Fire Risk Assessment

Property assessed: 1-20 72 Cambridge Road London
NW6 5FN

Client: Network Homes Group

FRA Inspection Date: 23/11/2021
FRA Issued to Client: 10/12/2021
FRA valid to: 10/12/2022
FRA completed by: Savills (UK) Ltd,
33 Margaret Street, London W1G 0JD
T: 020 7409 8737
E: fireriskhousing@savills.com

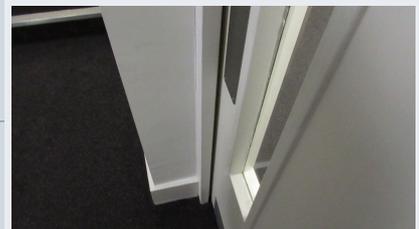
Question	M.2	<p>Comment: Excessive gaps were noted under some common area fire doors which will not resist the passage of cold smoke, Basement floor - store cupboard (under stairs)-18mm, store cupboard-13mm, single riser-19mm, electrical riser-18mm, water riser-19mm, duct riser-19mm, car par/lift lobby door-13mm, car park door-17mm, Ground floor - bicycle store door-20mm, bicycle lobby door-7mm, water riser-17mm, duct riser-6mm, stairs to basement lobby door-10mm, First floor - lobby-8mm, Second floor - lobby-13mm, electrical riser-13mm, water riser-13mm, Third floor - lobby-12mm, electrical riser-12mm, water riser-10mm, duct riser-6mm, Fourth floor - lobby-14mm, electrical riser-14mm, water riser-12mm, duct riser-9mm, Fifth floor - lobby-11mm, electrical riser-8mm, water riser-9mm, Sixth floor - lobby-8mm, electrical riser-10mm, water riser-9mm, duct riser-8mm, controls cupboard-10mm. Also it was noted some of the common fire doors have excessive perimeter gaps, Basement floor - single storage cupboard-6mm side, electrical riser-7mm centre gap, water riser-6mm centre gap, duct riser-5mm side, Ground floor - bicycle looy-6mm side, bicycle store-5mm side, duct riser-6mm top, basement access lobby door-6mm top, First floor - lobby-5mm top, water-8mm centre and 5mm top, duct riser-6mm top, Second floor - lobby-5mm top, electrical riser-5mm centre, duct riser-6mm top, Third floor - lobby-7mm top, electrical-7mm centre, water-5mm centre, duct-7mm top, Fourth floor - lobby-5mm top, Fifth floor - lobby-7mm top, electrical-6mm centre, water-7mm centre, duct-8mm top, Sixth floor - water-5mm centre, duct-7mm side, controls cupboard-6mm centre. Also the ground floor stairs lobby door is warped and not sitting into the frame.</p>

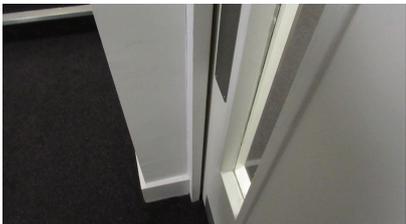
Comment: It is not possible to confirm that the glazing to the common area fire doors is fire rated at the time of inspection because there are no visible markings (or those present relate to safe breakage only). Ground floor - stairs lobby door. This door has been recommended for replacement, see M.2.

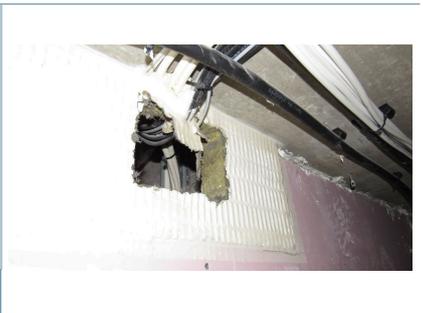
Question - Q.2: Are any hidden voids identified during the inspection appropriately enclosed and/or fire-stopped? (consider above suspended ceilings and behind casings)	No
Comment: Compartmentation breaches were noted from sample inspection of the voids above the false ceiling. Second floor - above the electrical riser door is a hole that has not been firestopped. Also the pipe exiting the refuse bin store does not appear to be adequately firestopped.

Recommendation: The compartmentation breaches noted within the voids above the false ceilings should be made good with appropriate fire-resisting materials/construction. The minimum period of fire resistance required is 60 minutes.			
Priority: B	Known Quantity: 2	Potential Quantity: 2	Action ID: 741822

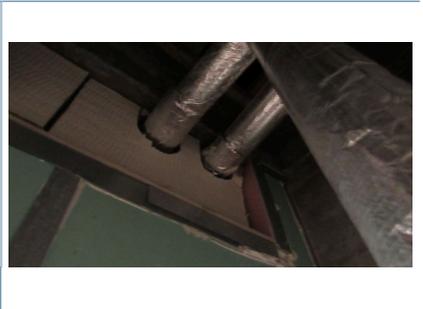
Question - Q.3: Are services risers, shafts, ducts and cupboards in the common area appropriately enclosed with fire resisting construction and adequately fire-stopped?	No
Comment: The services riser/cupboards sampled did not appear to be adequately fire resisting and/or fire-stopped. Firestopping was not adequately sealed within some of the service riser cupboards, Second floor - water riser, Sixth floor - water riser.

Recommendation: The firestopping noted should be sealed with a suitable fire-stopping material such as an intumescent paste. The minimum period of fire resistance required is 60 minutes.			
Priority: B	Known Quantity: 2	Potential Quantity: 2	Action ID: 741819
